STATE OF WASHINGTON  
**STATE BUILDING CODE COUNCIL**

**Title: Fixed Guideway Transit and Passenger Rail Systems Stations – Fire Protection**

**Proponent: Kym Williams, Sound Transit  
Title: Acting Director, Regulatory Permitting  
Date: May 20, 2021**

Figure 1- Elevated Open Stations Example (130th Street Station North Seattle)

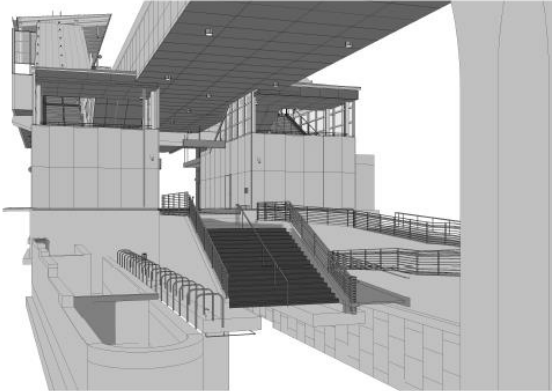
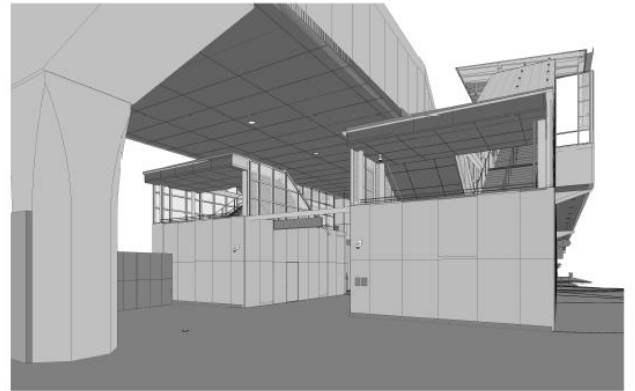
For open stations the proposal calls for fire protection where the protection adds value but not throughout as would be required for assembly occupancies per IBC/IFC 903. Open stations include stations at grade and grade separated (elevated or recessed) that meet the NFPA 130 definition for *open station*. Areas that would not require fire protection, for example at an elevated open station, would include noncombustible canopies, concourses, exit stairs, exit access stairs, exterior stairs, ramps, plaza and other open areas below the platform. All of these areas (except enclosed stairs when provided) are unenclosed. Smoke and products of combustion would readily vent to the atmosphere. Noncombustible construction is required by NFPA 130.

Station are required to be of noncombustible construction and open stations would vent products of combustion and are less likely to become untenable. While a group A-3 occupancy is intended to be a catch-all for assembly occupancies that do not clearly fall into the other divisions. Transit stations are unique and fire protection does not, in all cases, add significant value to open stations of noncombustible construction. See open station full perspective 3D drawings below.
